THE CLEVELAND ELECTRIC ILLUMINATING COMPANY

August 31, 1982

Perry Nuclear Power Plant
Docket Nos. 50-440; 50-441
SER Open Item - No. 16
Fire Protection for the PGCC System

PGCC SUBFLOOR CO₂ FIRE EXTINGUISHING SYSTEM

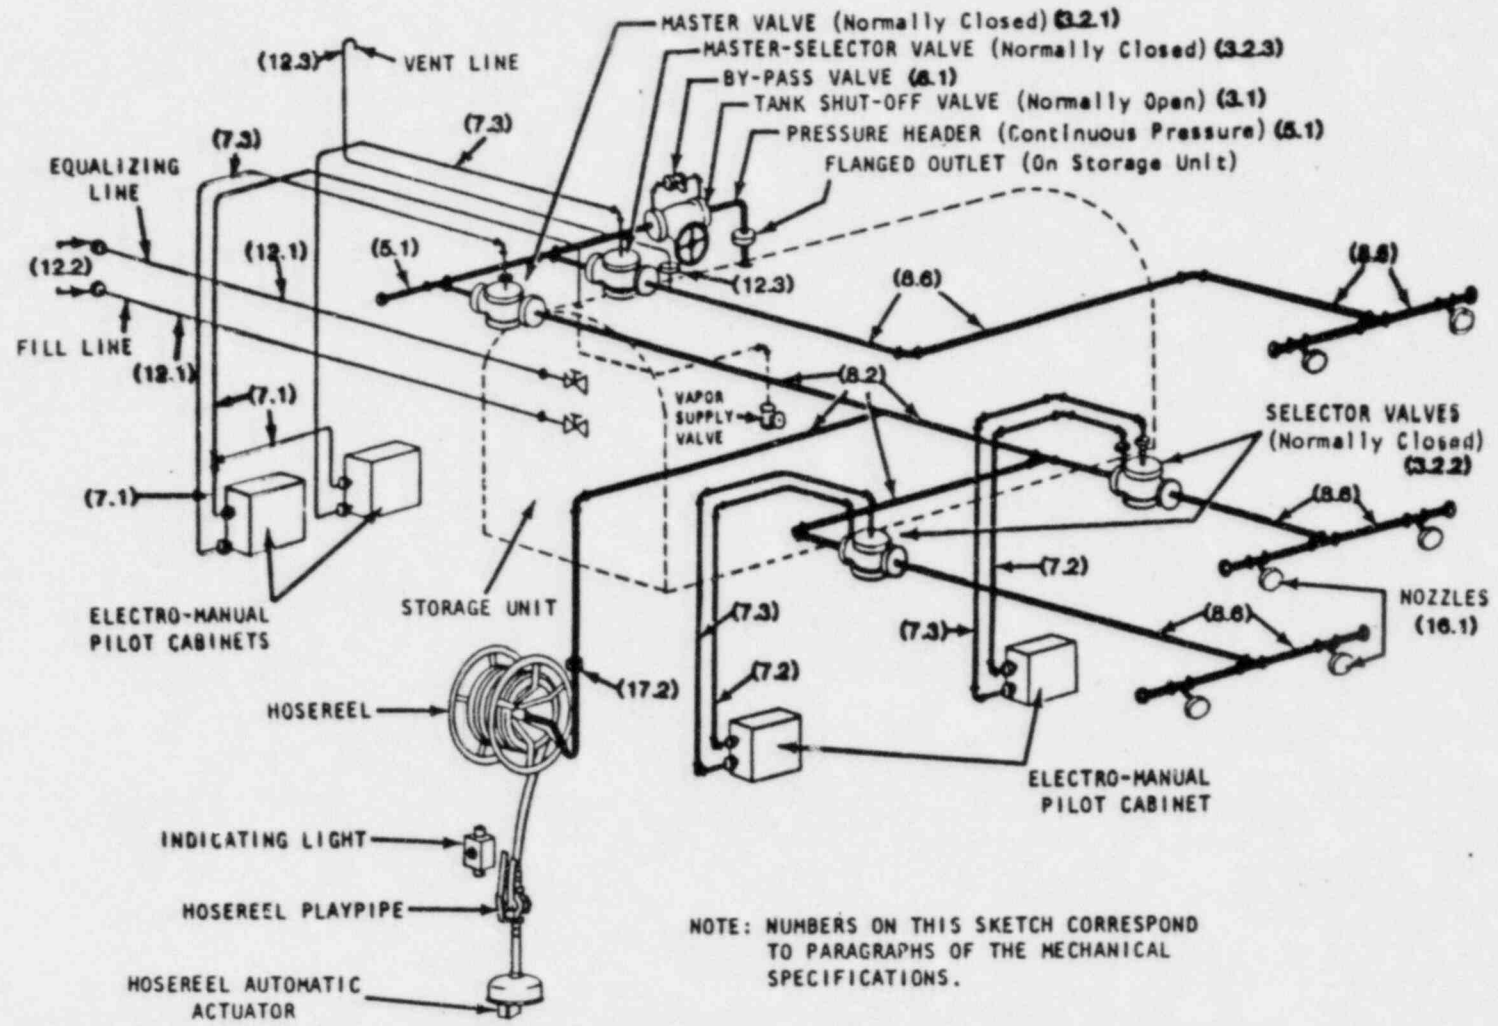
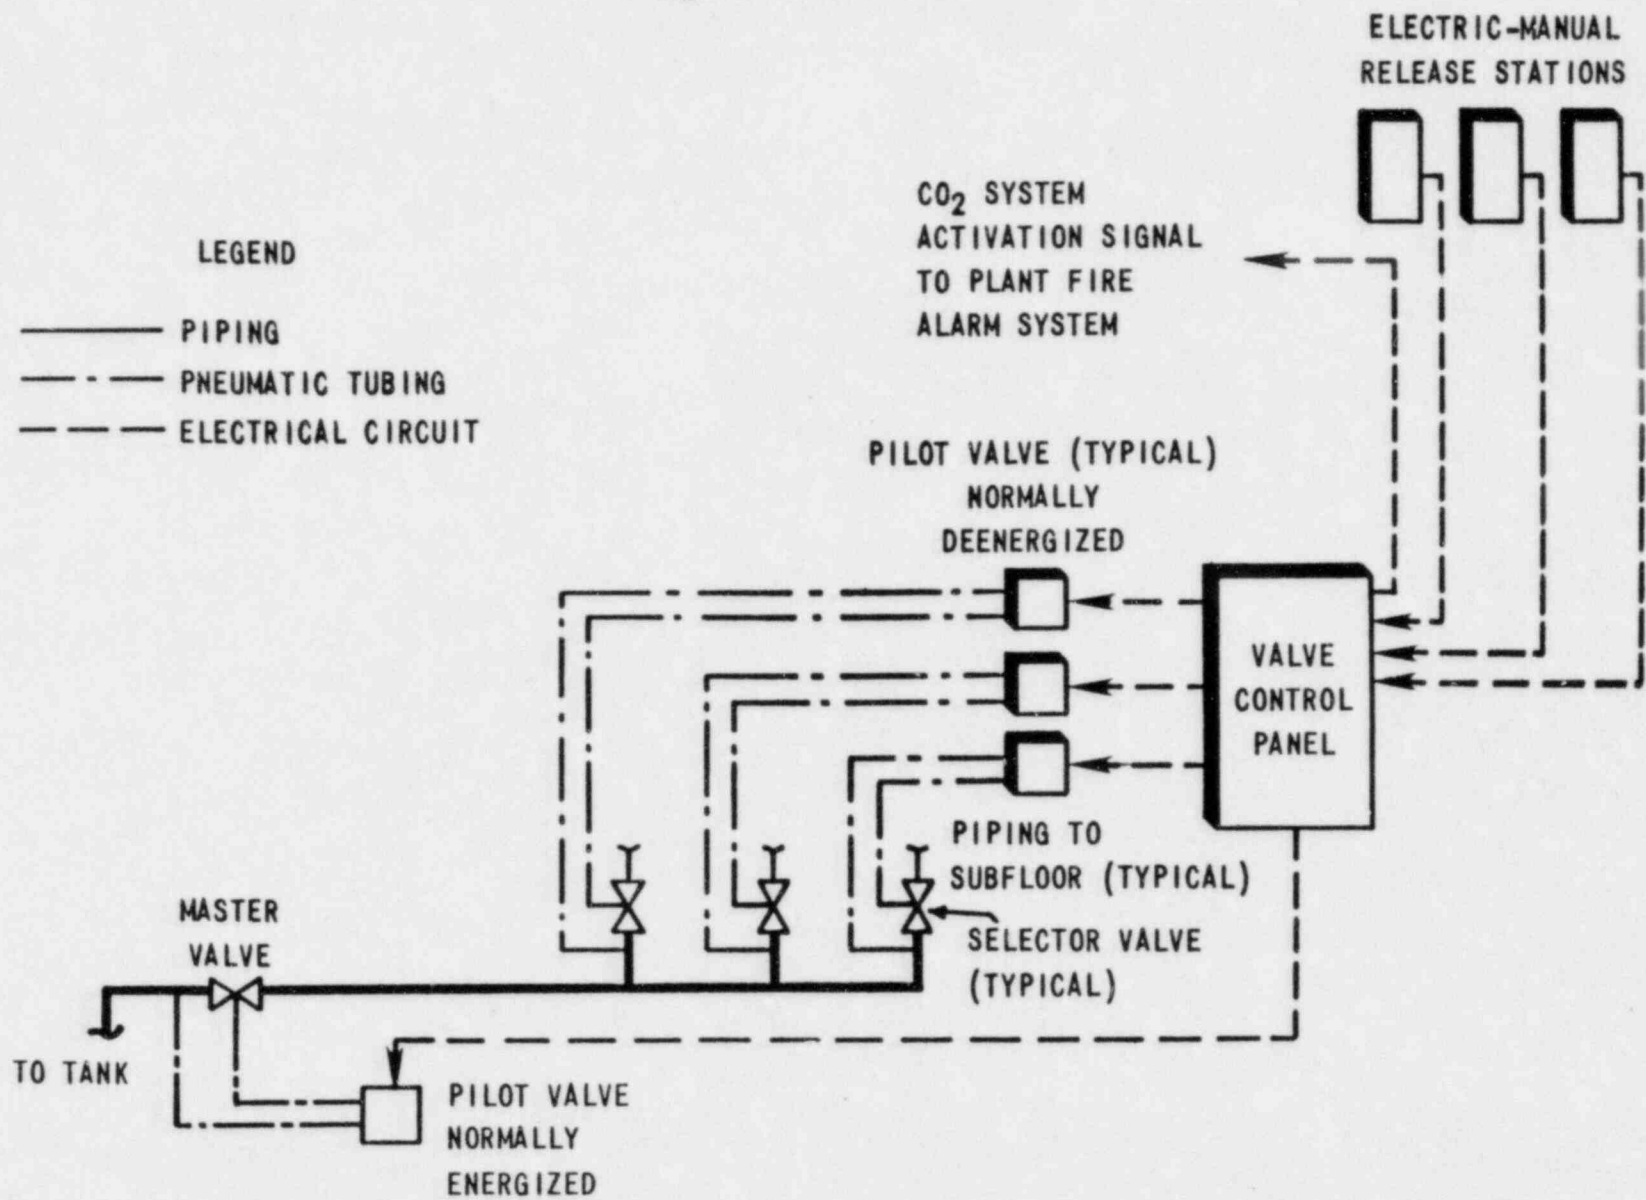
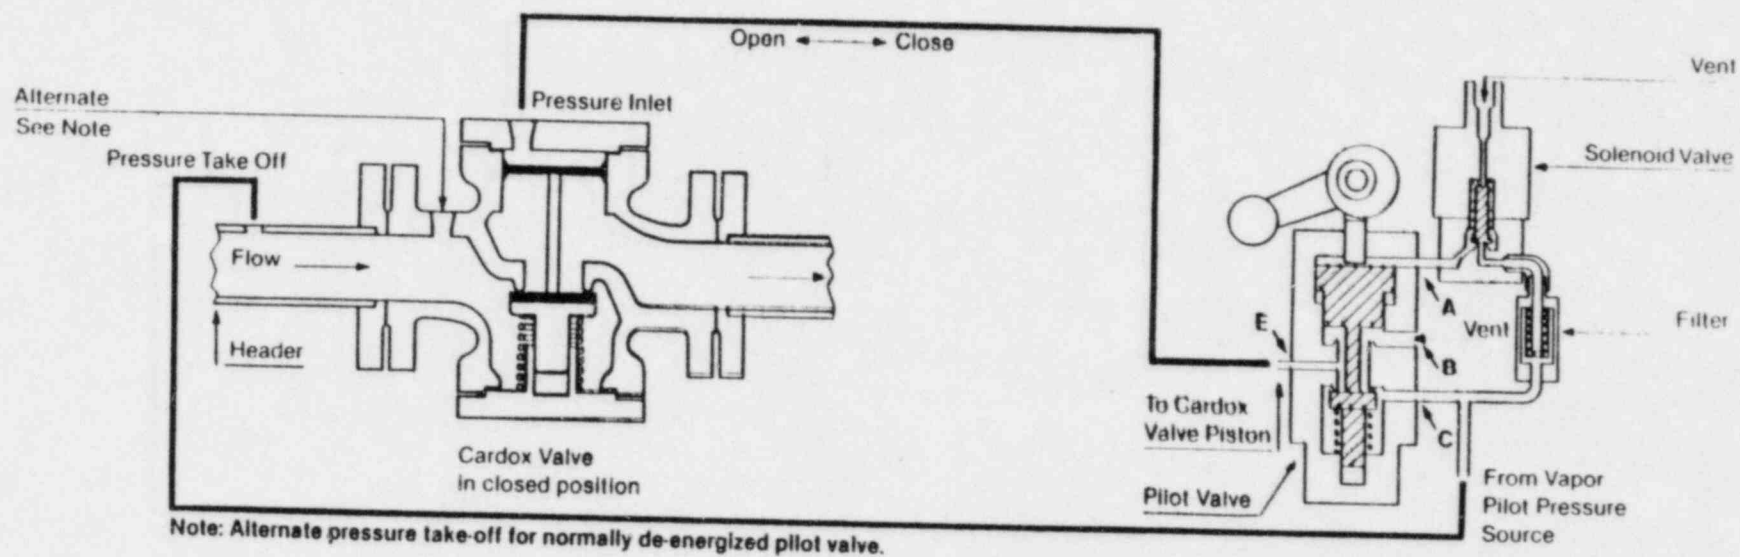
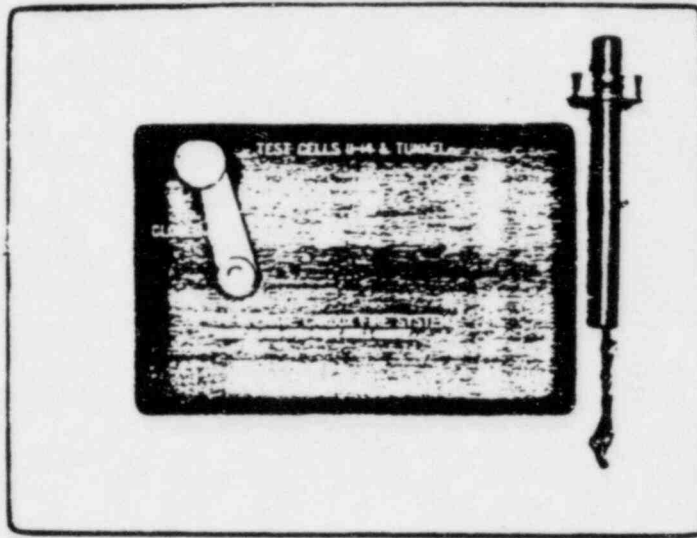
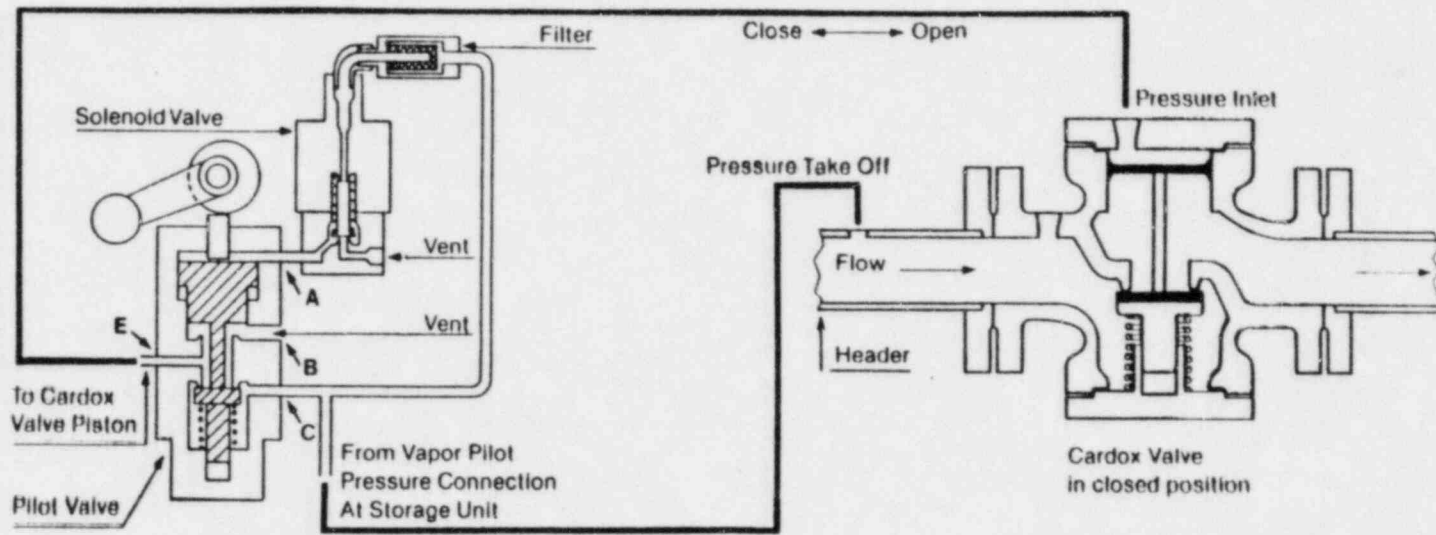
- 281.11 Describe the carbon dioxide extinguishing system for the control room, include piping diagrams, wiring diagrams, component drawings. Describe the normal system operation for fire suppression and describe the features between the carbon dioxide storage tanks and the control room. Describe the seismic design of the carbon dioxide system.

The carbon dioxide system for the Power Generation Control Complex (PGCC) subfloor consists of several components. The major component is the 1¼ ton storage tank, which is located outdoors and will contain 1000 pounds of liquid at 0°F and 300 psi. It is kept at this temperature by means of a refrigeration unit and by insulation around the tank. The remaining system components are responsible for transmitting the carbon dioxide to the hazard. They consist of the piping, master and selector valves, pilot valves, nozzles, electric manual release stations, control panel and associated wiring.

The carbon dioxide systems for the PGCC are operated electrically by their respective electric manual release stations located in the control rooms. Operation of the electric-manual release station sends a signal back to the local panel which actuated a timed release of carbon dioxide to the hazard area. The design sequence will flow approximately 250 pounds of carbon dioxide based on design concentrations and volume of the protected area. This is a conservative quantity and contains a safety factor of three based on the largest hazard. This design approach is in accordance with requirements of NFPA Standard 12. Should the acceptance tests prove it to be necessary, the timer sequences may be adjusted to ensure that the design concentration is achieved as required.

Both the master valve and the selector valve operate by the same principle, they are both closed until the pilot valve (located adjacent to its associated master or selector valve) is actuated. This actuation of the pilot valve allows the pressure in the piping to enter the piston chamber of the master or selector valve and force the piston into the open position to permit the flow of carbon dioxide through the valve. The piping network consists of several selector valves located downstream of the single master valve. The opening of a particular series of master and selector valves will allow carbon dioxide to flow into an individual hazard area and extinguish the fire.

The system can be operated manually upon loss of power. Upon loss of power, the master valve opens automatically allowing the carbon dioxide to flow to each selector valve. Each selector valve can be operated manually by opening the associated pilot valve lever located in a cabinet with a break glass cover. These cabinets are located in the hallway below the control room. The selector valve will then continuously discharge carbon dioxide until the lever is returned to its original position.

There are no requirements for seismic design for the fire suppression systems. Piping diagrams, wiring diagrams and components are attached.
